PLAN COMMISSION/HISTORIC PRESERVATION COMMISSION AGENDA

Consideration of Design Review Application for Upland Hills Health Mount Horeb Clinic Remodel, 1809 Springdale Street

To: Village of Mount Horeb Plan Commission
From: Village Planner Ben Rohr, AICP
Date: January 24, 2024
Re: Village Planner's Site Plan and Design Review Comments for a Proposed Building Addition for Upland Hills Health at 1809 Springdale Street.

VIEW FROM SOUTH PARKING LOT - NEW ENTRY / ADDITION

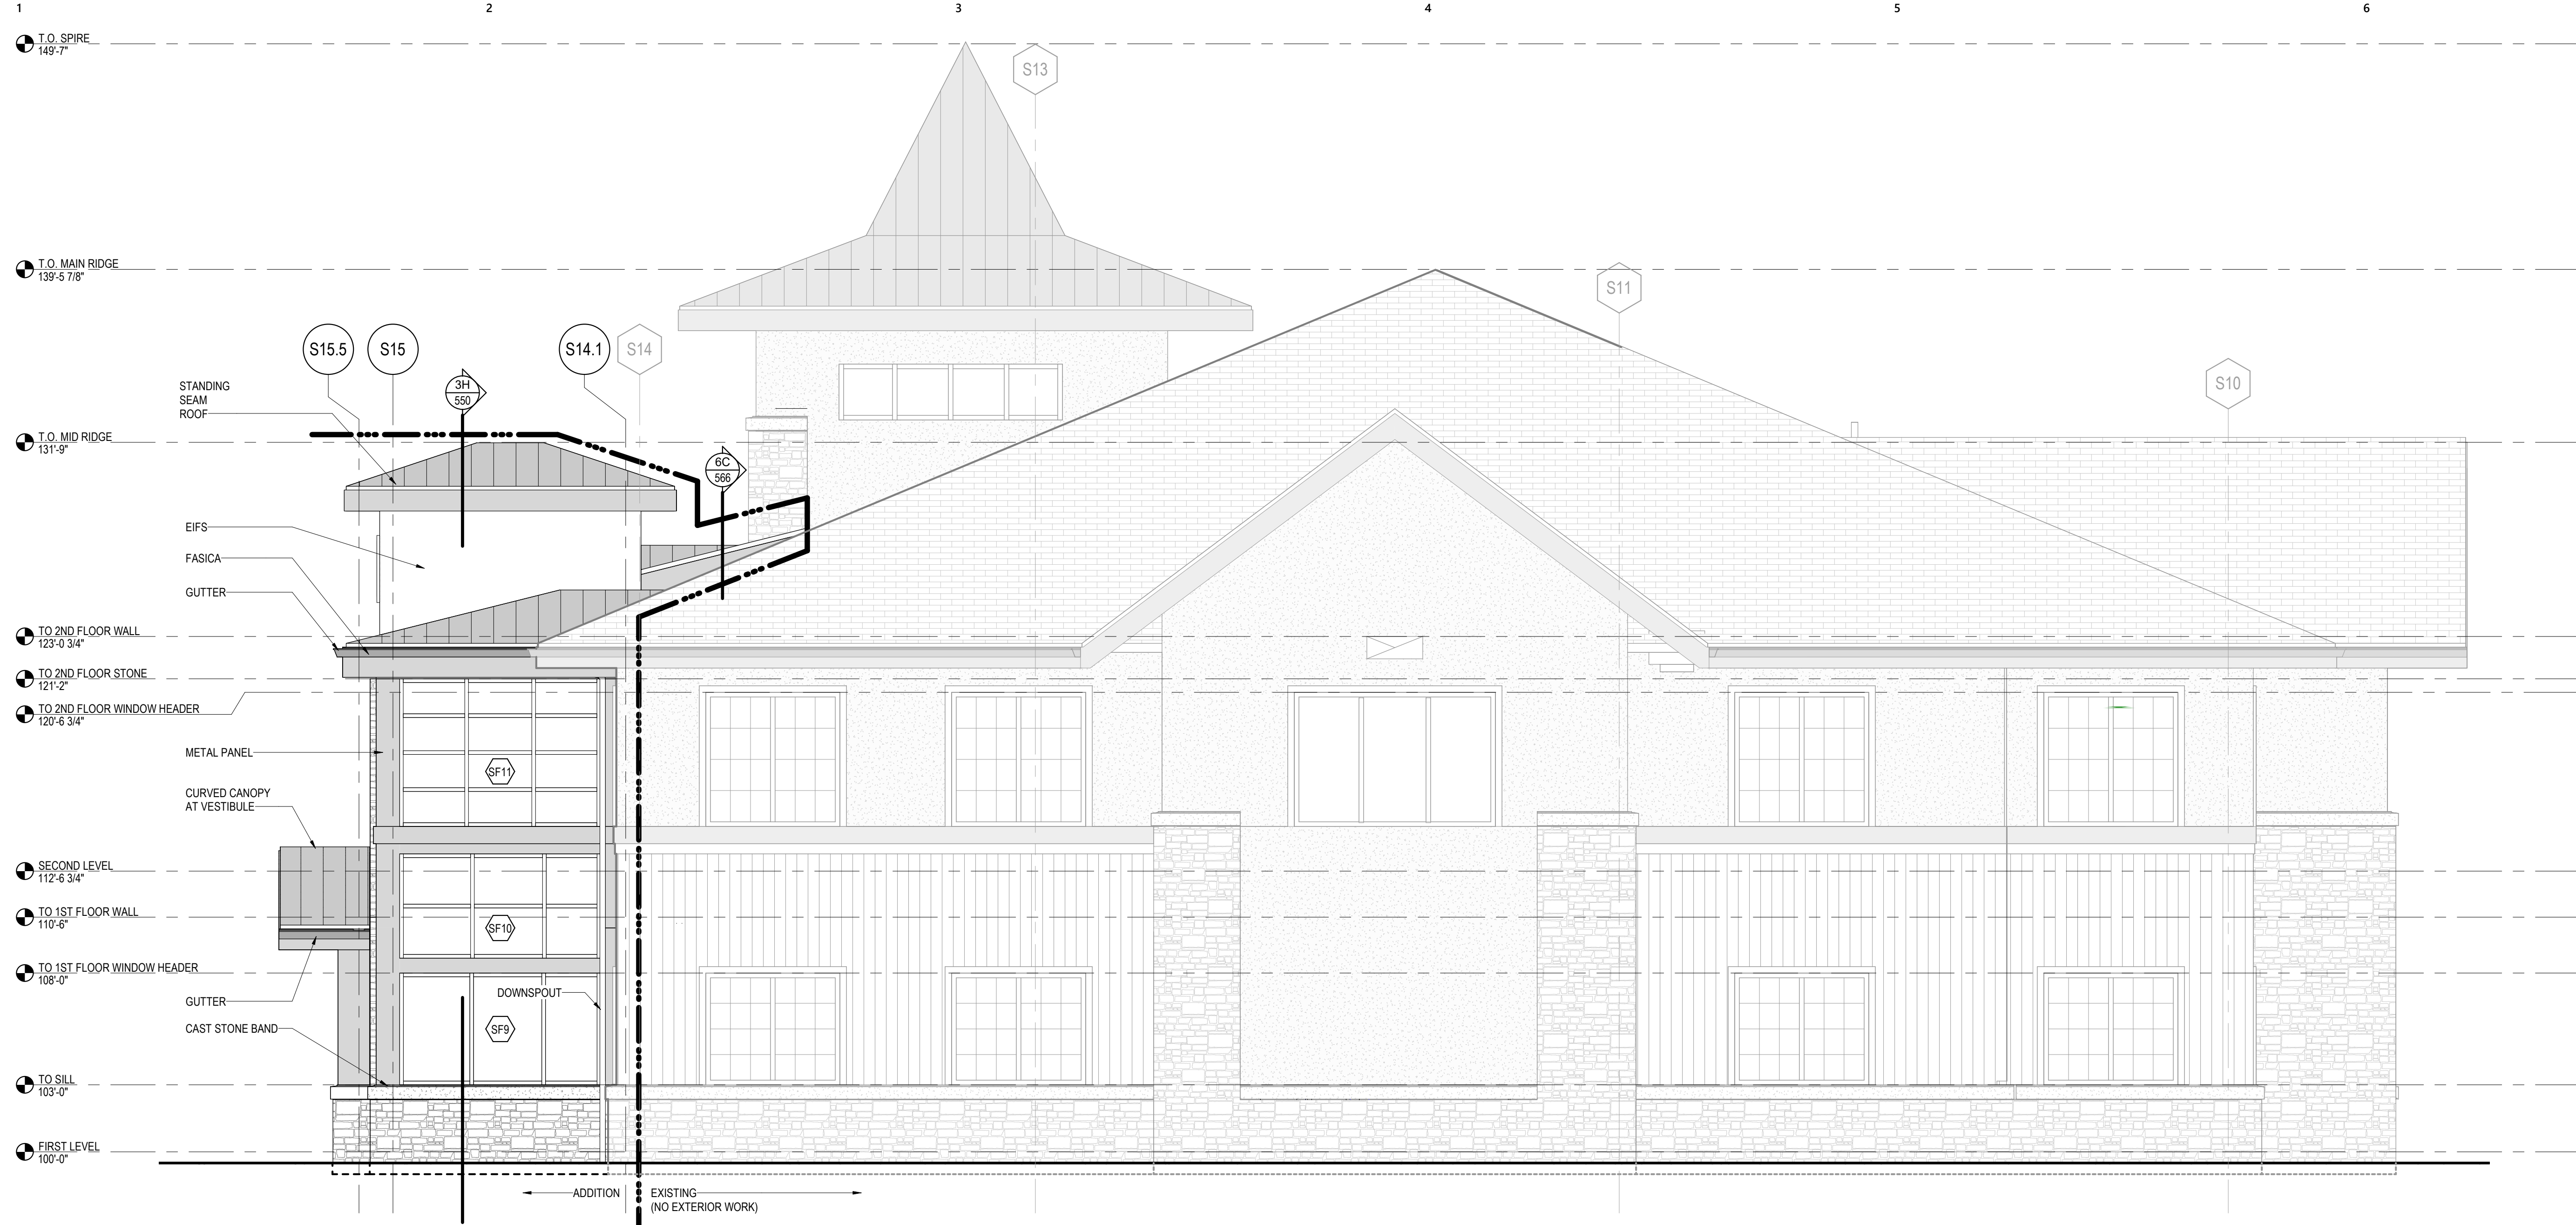
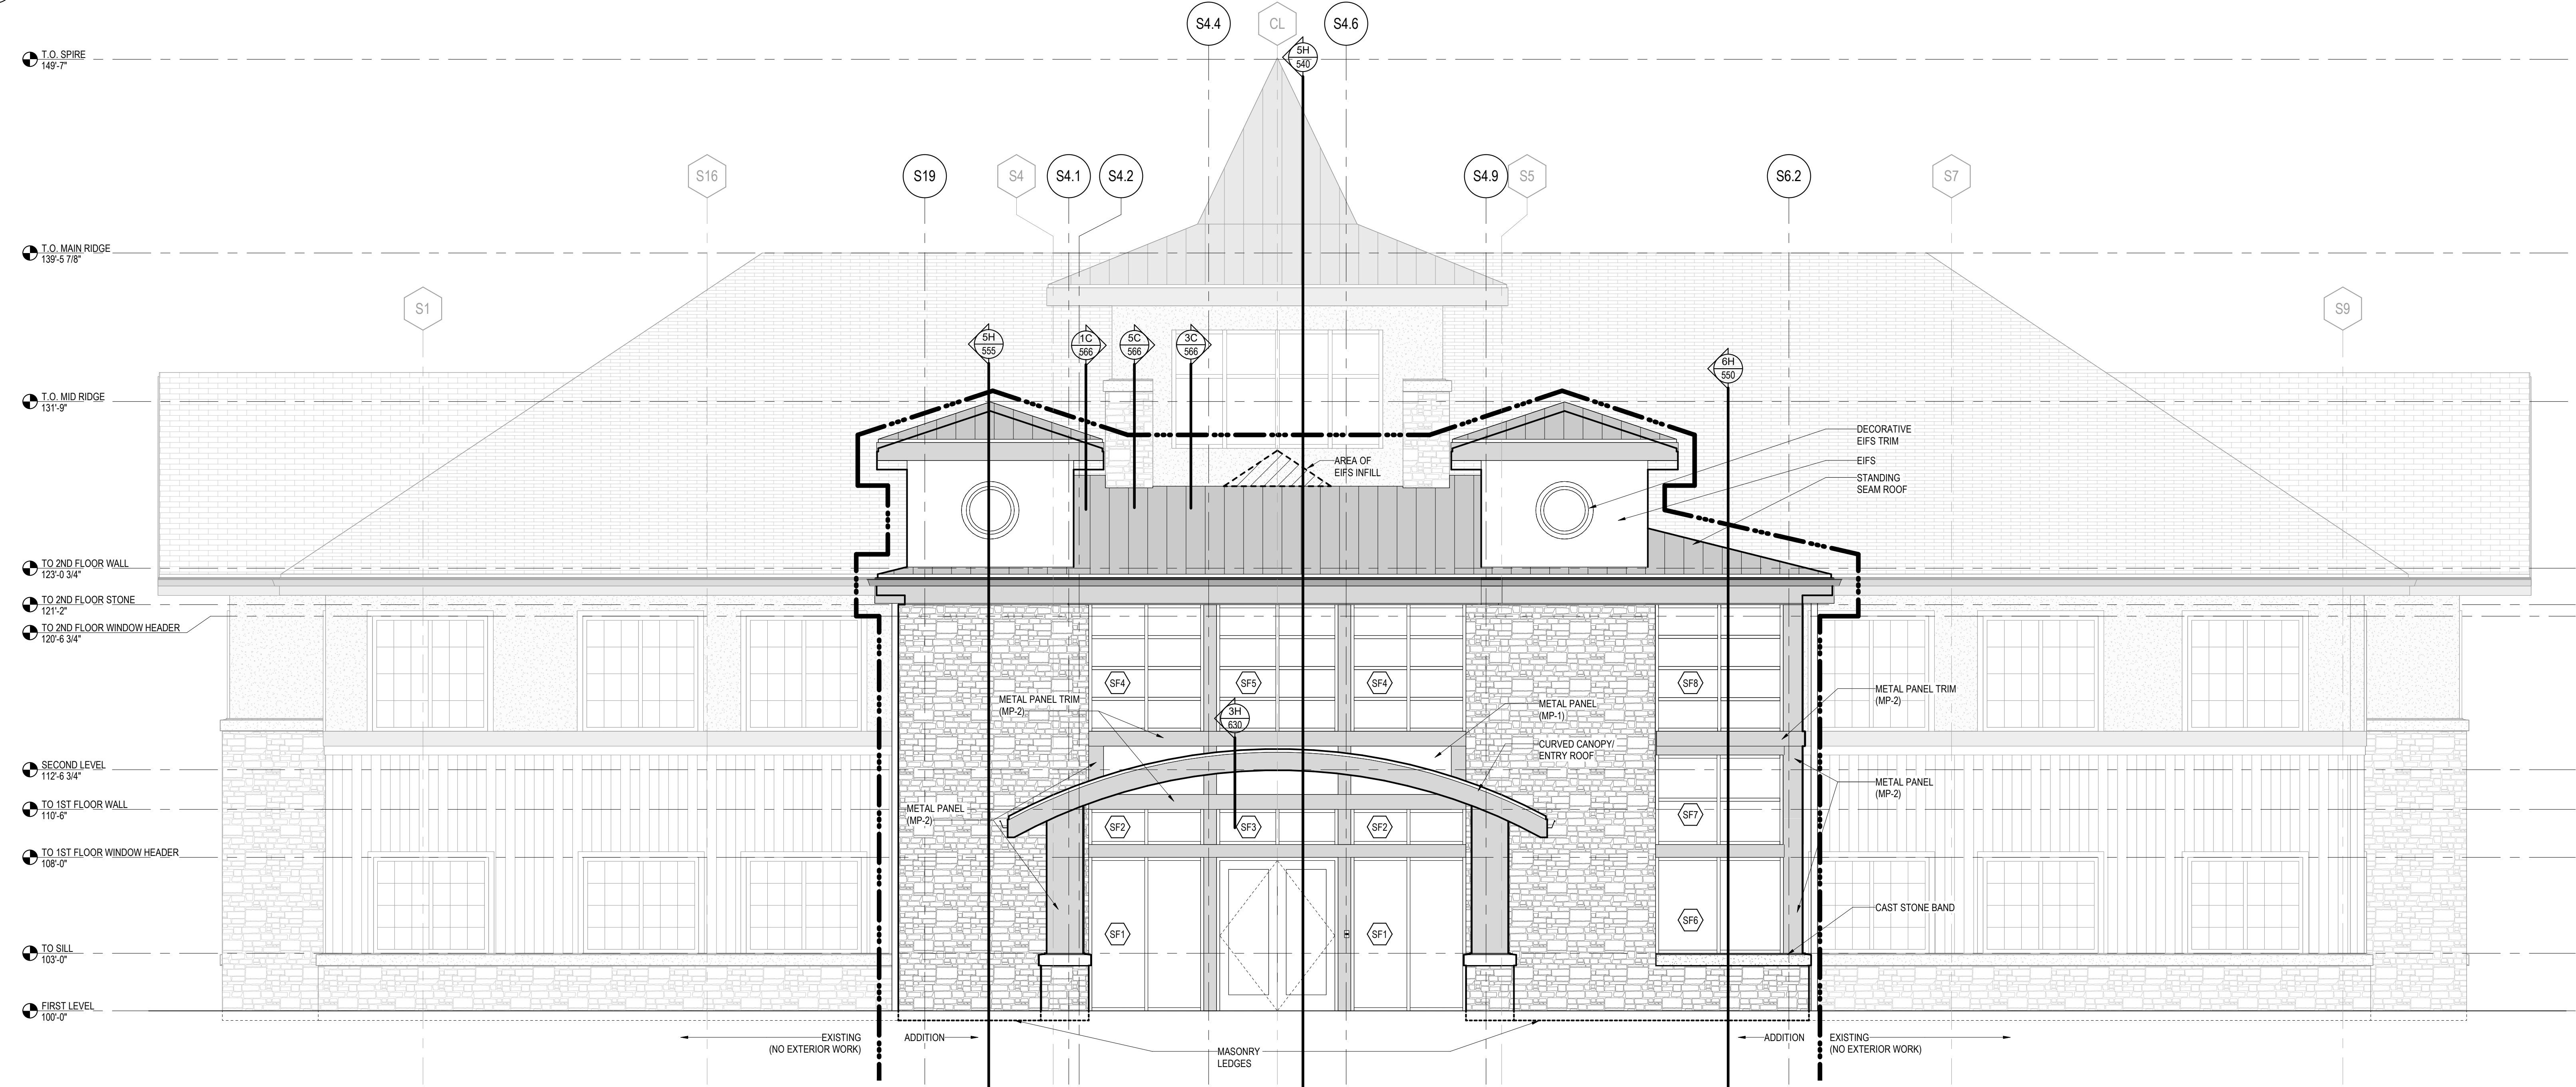
- a. All exterior doors visible from streets, drives or parking areas shall provide decorative design elements.
 - This requirement is met using glass doors, columns, a canopy, and the existing tower element centered over the main entryway.

- Awnings, where approved by the Plan Commission, shall complement the character of the building.
 - This requirement is met. The proposed arched metal canopy over the main entryway compliments the design of the structure and highlights the entry doors.
- Soft, weather-treated canvas or vinyl materials which allow for flexible or fixed installation may be used. Metal canopies are prohibited.
 - This requirement is not met. The canopy is proposed to be constructed of metal. I believe that this requirement should be waived.
- Backlighting is prohibited.
 - This requirement is met. None proposed.

Sheet Title
ELECTRICAL SITE PLAN

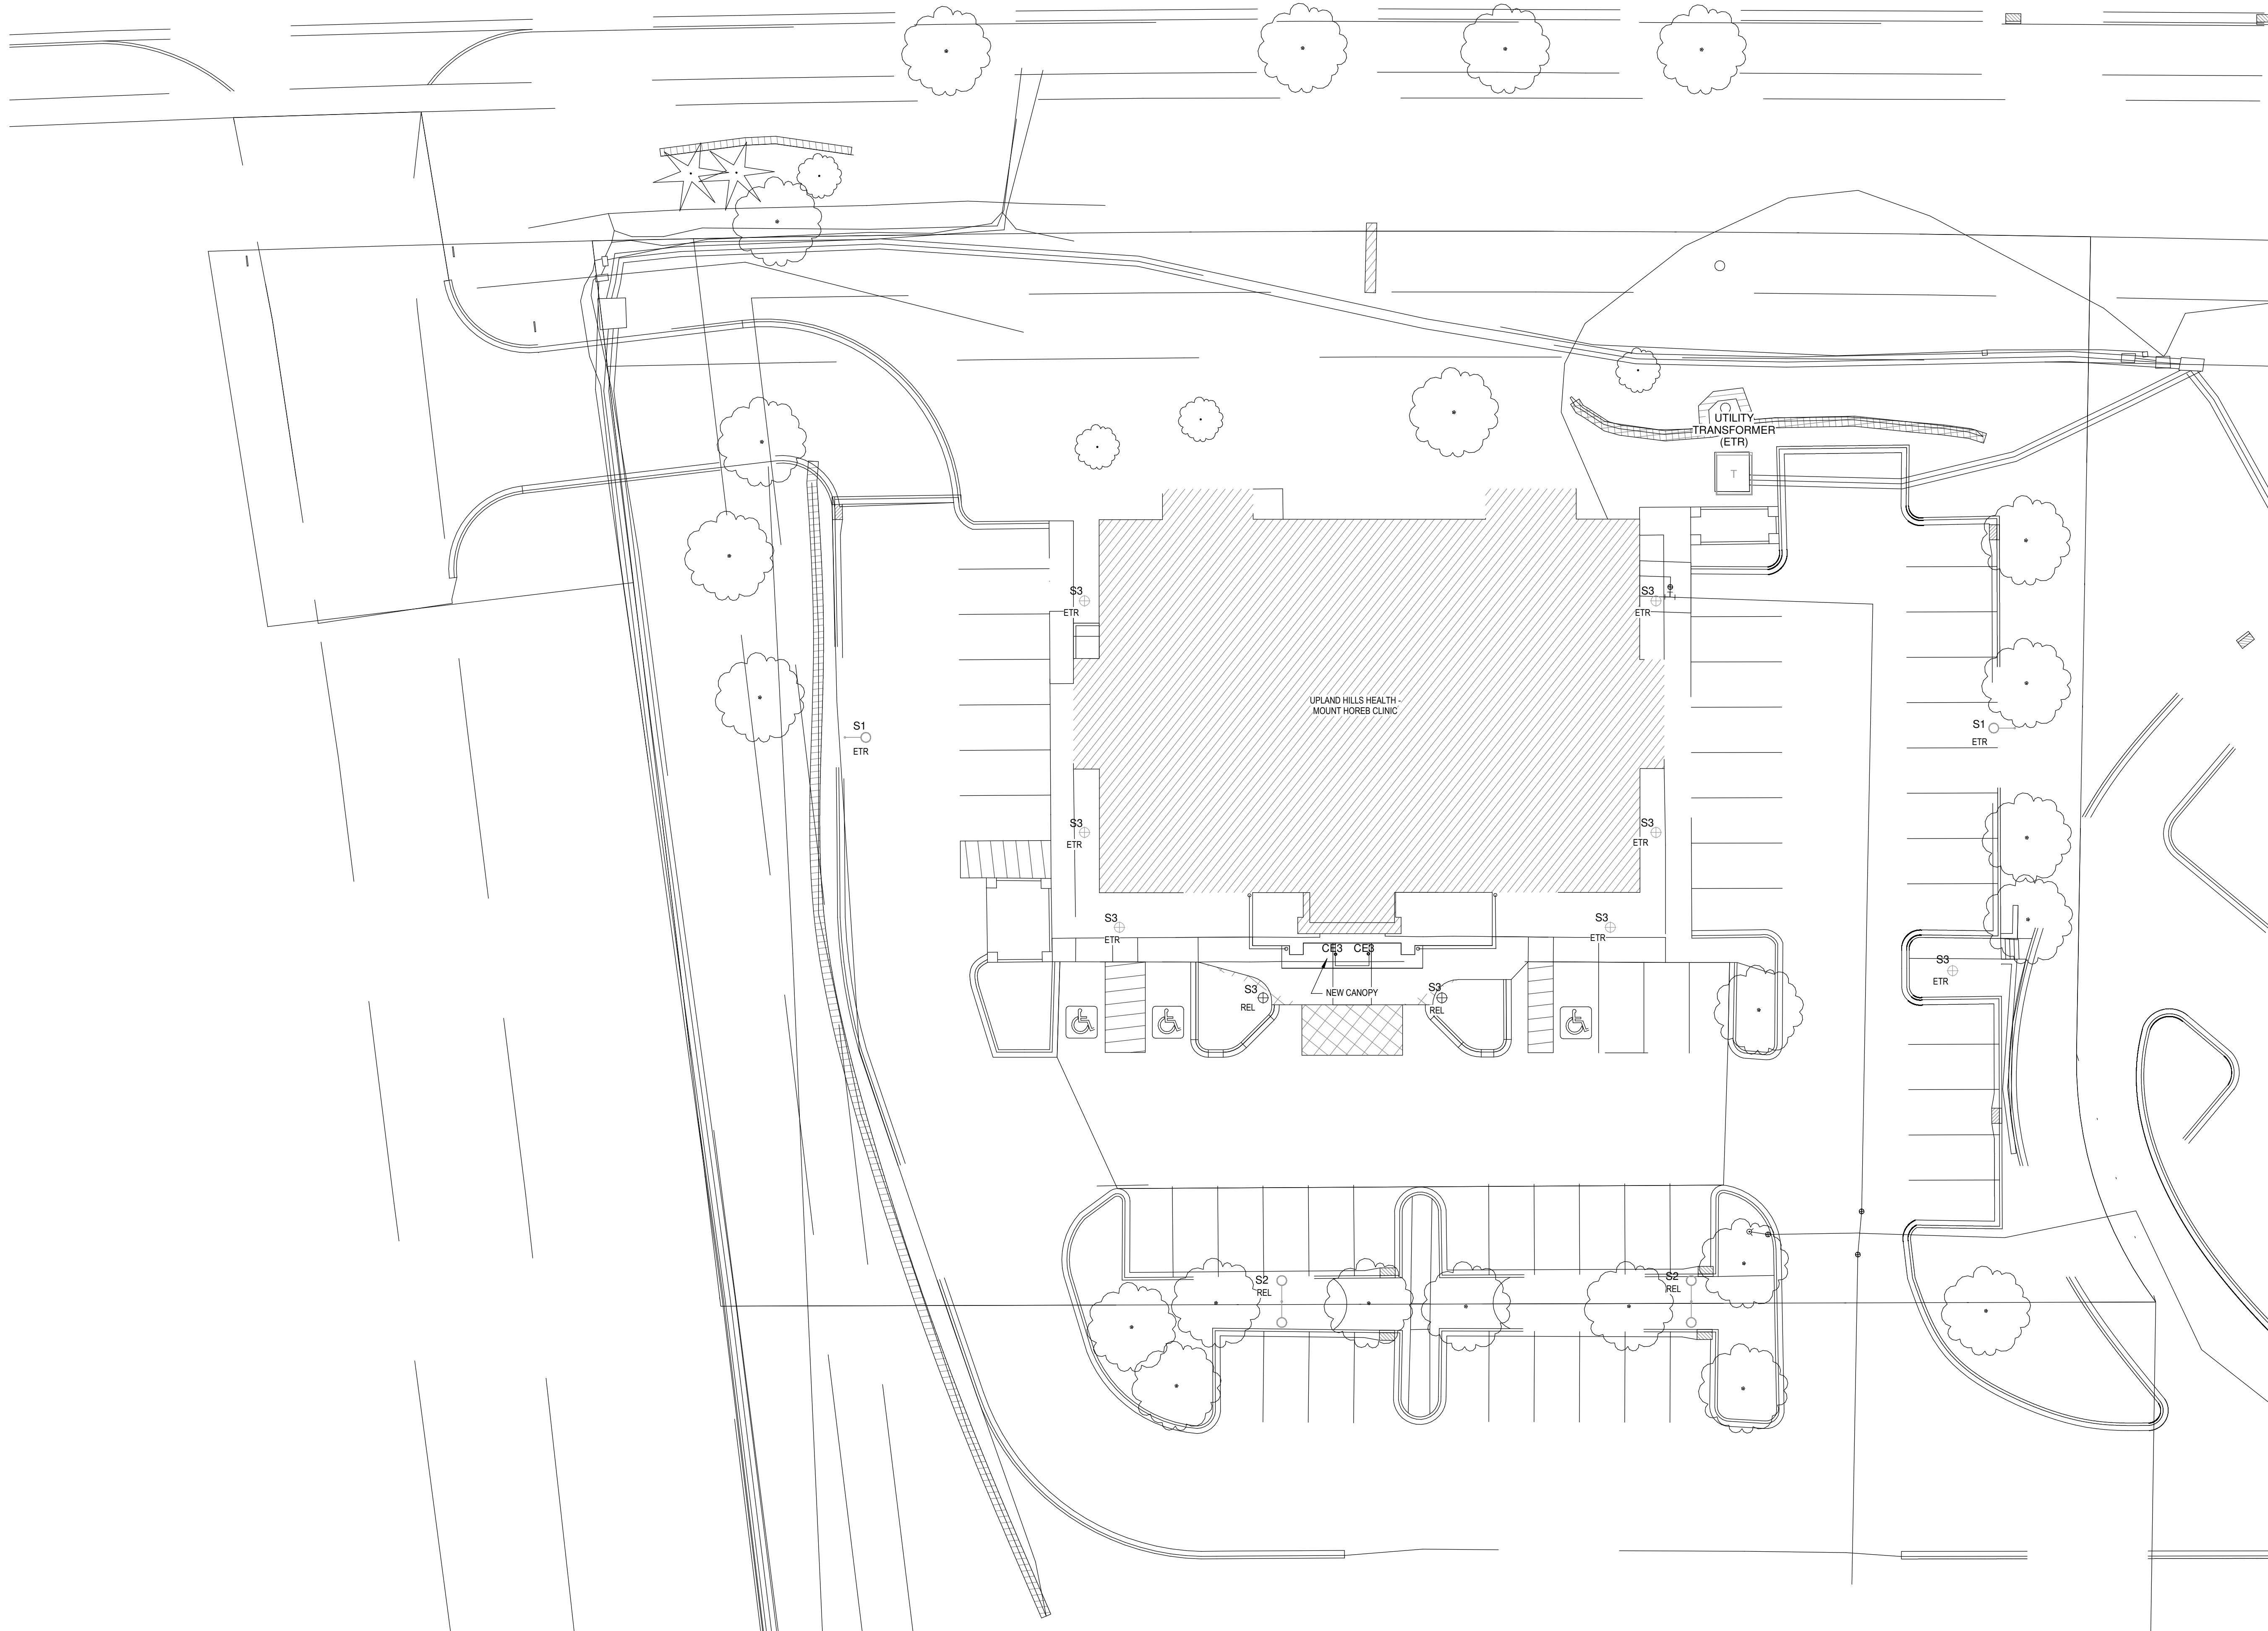
Per conversation between Keith Dalsing and Mt Horeb, our understanding is that a photometric plan is not required since existing lighting is to remain. At the village's request we are adding lighting under the new entry canopy.
